**39 Oak Avenue  
Ickenham  
UB10 8LR**

## **PLANNING STATEMENT**

*Erection of a replacement dwellinghouse*

**Fig.1 – Comparison images showing the reduction in the crown roof profile**

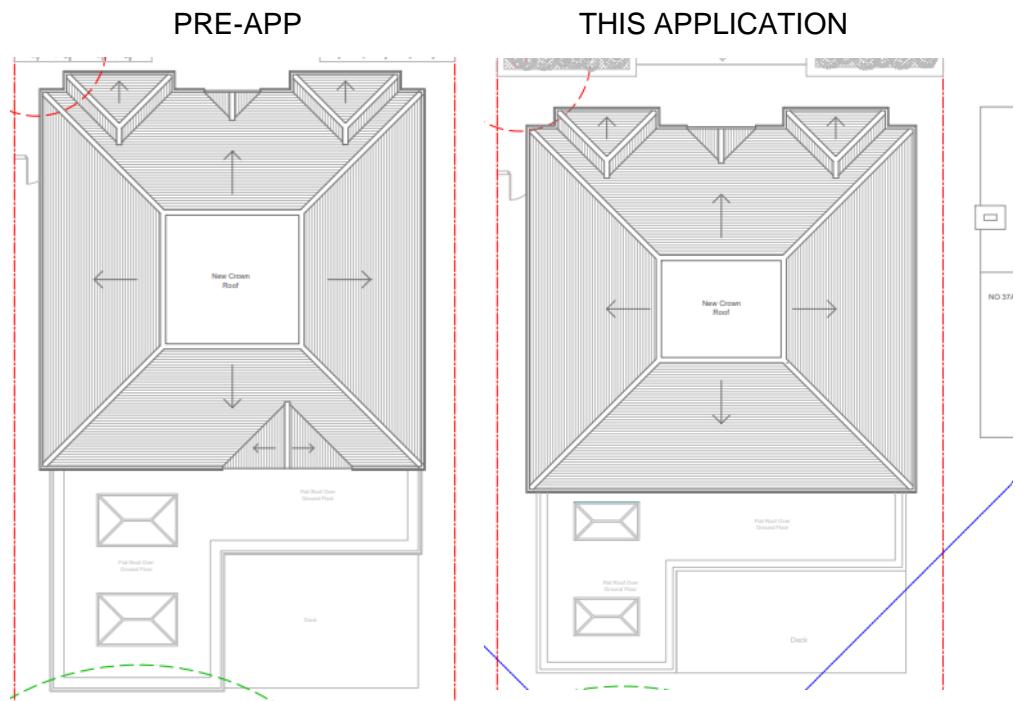
- 2.1 This council's pre-application response was supportive of the design concept of the replacement dwelling but requested that amendments be made to the crown roof profile in that '*the central flat roof element is reduced to resemble the appearance of the crown roof profile at no.38 Oak Avenue.*'
- 2.2 The crown roof profile has been amended in accordance with the council's request and this is demonstrated in Fig.1 below.

**Fig.2 – Image showing how the proposed ridge height matches that of 37a Oak Avenue**

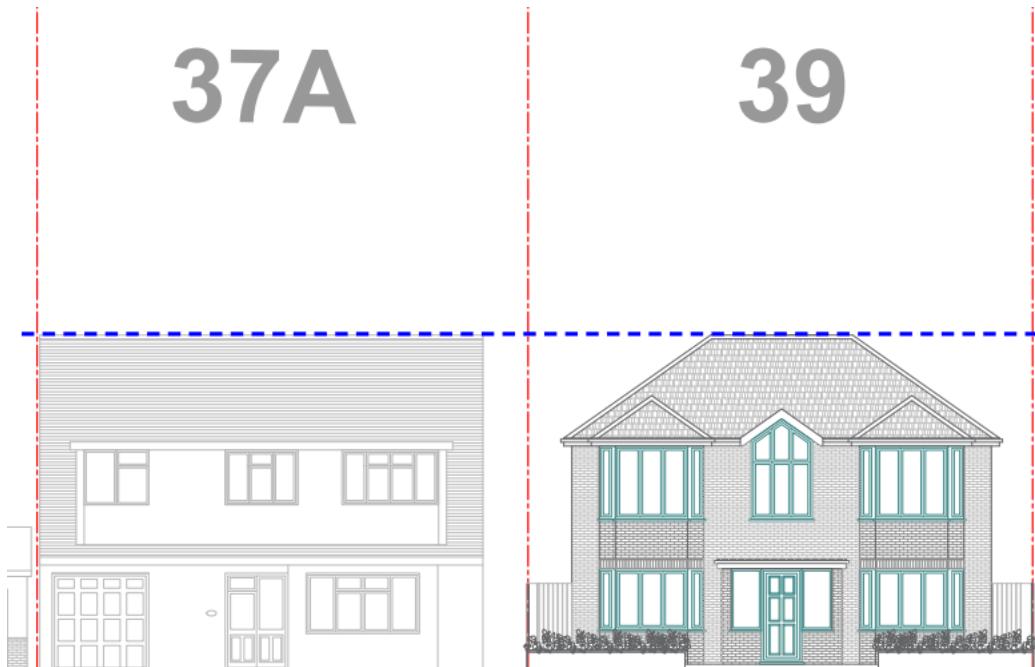
2.3 The council's pre-application letter also stipulated that '*the ridge height of the proposed replacement dwelling would need to match the ridge height of the property at no.37a Oak Avenue.*'

2.4 The ridge height of the proposed dwelling has now been amended so that it is commensurate with that of no.37a Oak Avenue, as demonstrated in Fig.2 below.

**Fig.4 – Excerpt of proposed first floor plan showing the rear dormer window at no.41 in relation to the proposed first floor building line.**

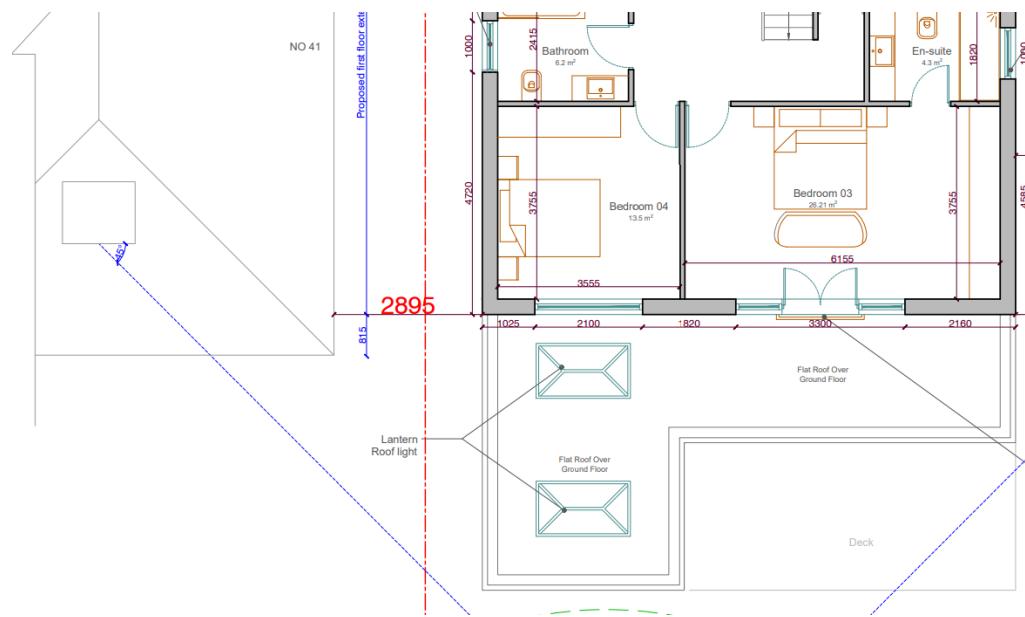
- 3.3 The council's pre-application comments were also concerned with the rear building line and how this would impact on the upper floor windows of the neighbouring properties on either side. The pre-application letter stated that:  
*'the rear building line would need to be reduced to overcome the harm caused to the living conditions of the occupiers of Nos. 37a and 41 Oak Avenue.' 45-degree test only relates to daylight and given position of dormers at 37a and 41, there will be unacceptable impression of enclosure which would be overbearing for these neighbouring occupiers. Also the outlook from these dormers would be severely undermined. Instead, it is strongly recommended that the depth of the proposed dwelling is reduced so that its*

*two-storey rear building line does not project beyond the rear dormer at no.37a (this would require a 1.6 metre depth reduction.'*

3.5 Firstly, in the case of no.41 Oak Avenue, the rear dormer window of this property is located high up in the rear roof slope (see Figs.3 & 4 below).

3.6 The blue lines in Fig.3 above indicate the reasonable line of vision from this dormer window; as the proposed first floor of the replacement dwelling does not even project beyond the rear wall of no.41 (see Fig.4 below) it is simply impossible for no.41's rear dormer to be affected by the proposed development in terms of outlook or sense of enclosure. This dormer occupies a position very high up in the rear roof slope of no.41 and will be unaffected by the proposed development.

**Fig.6 – Images showing views of the existing ground floor rear extension.**

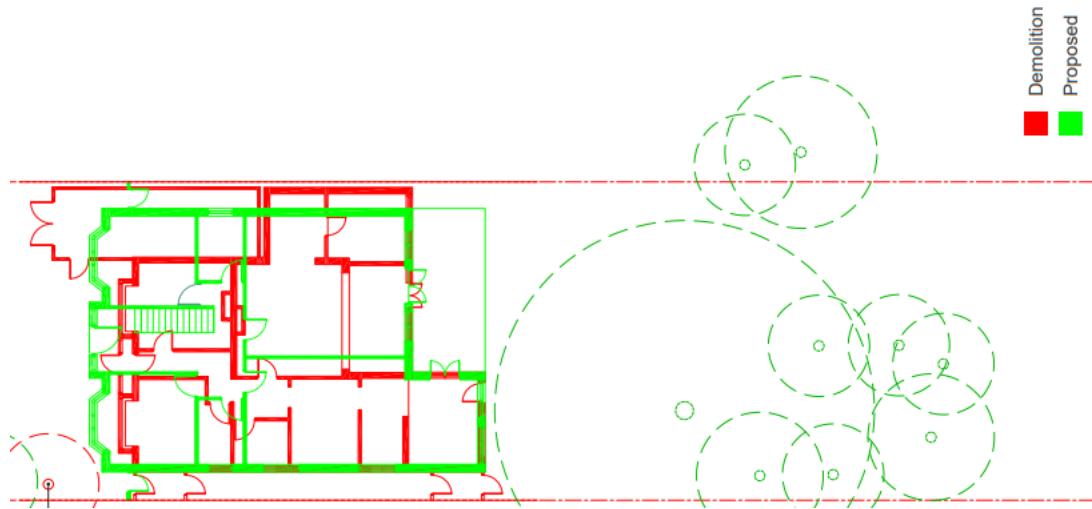
3.10 The pre-application advice also commented that the proposed ground floor depth (which proposed an additional 1-metre depth beyond the existing ground floor flat roof extension) was unacceptable, stating that: '*the depth of the ground floor rear element would be unacceptably overbearing for the occupiers at Nos. 37a and 41 Oak Avenue, given the position of these neighbours' ground floor windows. Officers would recommend that the proposed single storey rear element is reduced to coincide with the reduction at first floor level.*'

3.11 The proposed ground floor rear element has been amended so that it does not protrude beyond what is currently on site.

3.12 The images in Fig.6 below show the extent of the existing flat roof ground floor rear extension at the application site. As this extension is in-situ, it is entirely reasonable to re-build this built form. The proposed development simply replicates an existing and long-established situation. Fig.7 below shows the outline of the existing and proposed footprint.

**Fig.11 – Excerpt of proposed forecourt plan**

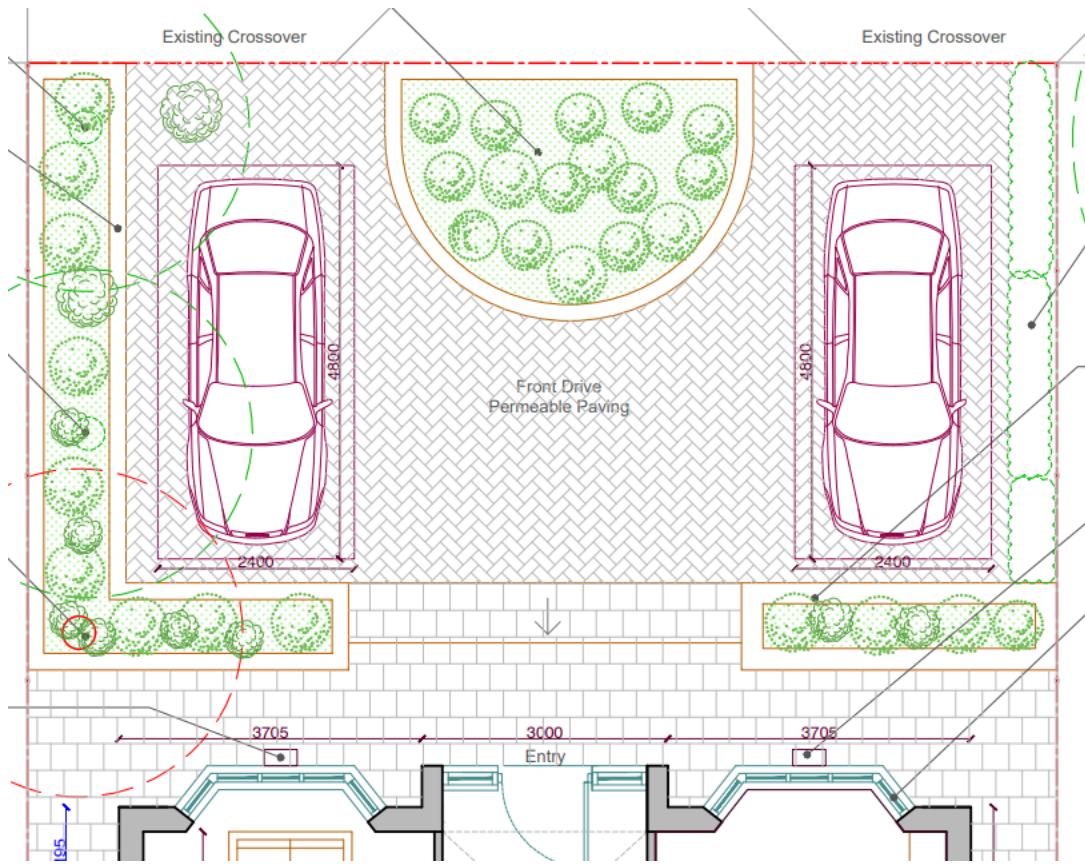
*'Front garden is indicated as predominantly paved area, with space for four or five cars and minimal soft/living landscape. This arrangement would be detrimental to the character and appearance of the area. It is environmentally unsound with regard to air quality carbon capture and Sustainable Urban Drainage System (SuDs). A greater area of soft landscaping should be retained / reinstated as part of the layout. Also, the reduced area of hardstanding would need to be covered in permeable paving.'*

4.2 The forecourt plan has been amended in line with the council's stipulations and parking is reduced to 2 off-street parking spaces and large areas of landscaping have been introduced as well as demonstrating that the paving will be permeable (see Fig.11 below).

4.3 In addition, the presence of the 2 existing crossovers is noted on the updated forecourt plan as well as position of wall-mounted EV charging points (on the main house) to comply with Policy T6 (T6.1) of the London Plan (2021).
